**Economic Commission for Europe****Inland Transport Committee****World Forum for Harmonization of Vehicle Regulations****Working Party on General Safety Provisions****110<sup>th</sup> session**

**Regulation No. 105 (ADR vehicles)****Proposal for the 06 series of amendments to Regulation  
No. 105 (ADR vehicles)****Note by the secretariat \***

The text reproduced below was prepared by the secretariat to align the provisions of UN Regulation No. 105 with those of the new 2017 edition of the European Agreement concerning the International Carriage of Dangerous Goods by Road (ADR). The modifications to the current text of UN Regulation No. 105 are marked in bold for new characters and strikethrough for deleted characters.

Model A  
(see paragraph 4.4. of this Regulation)

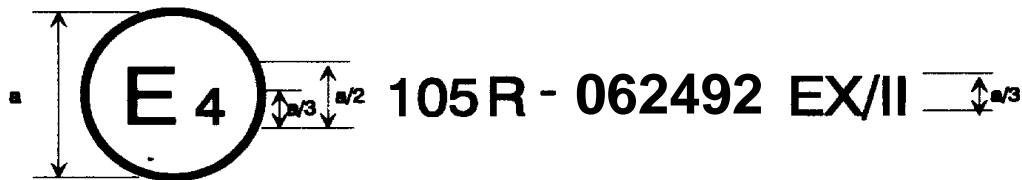
Annex 2, amend to read:

The above approval mark affixed to a vehicle shows that the vehicle type concerned, intended for the transport of dangerous goods, has been approved in the Netherlands (E 4), pursuant to Regulation No. 105, under the approval number ~~052492~~ **062492** and designated EX/II (according to paragraph 9.1.1.2. of Annex B to the ADR). The first two digits of the approval number indicate that the approval was granted in accordance with the requirements of Regulation No. 105 as amended by the ~~05 06~~ series of amendments.

Model B  
(see paragraph 4.5. of this Regulation)

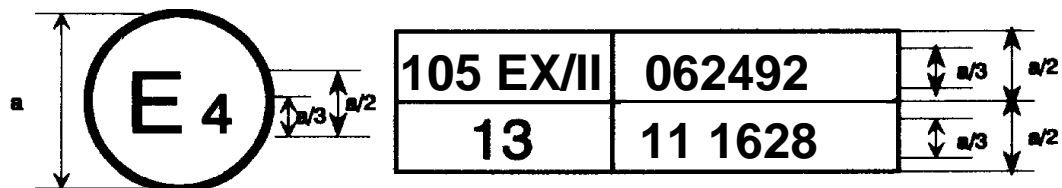
The above approval mark affixed to a vehicle shows that the vehicle type concerned has been approved in the Netherlands (E 4) pursuant to Regulations Nos. 105 and 13<sup>1</sup>. The first two digits of the approval numbers indicate that, at the dates when respective approvals were granted, Regulation No. 105, as amended by the ~~05 06~~ series of amendments, while Regulation No. 13 already included the 11 series of amendments.
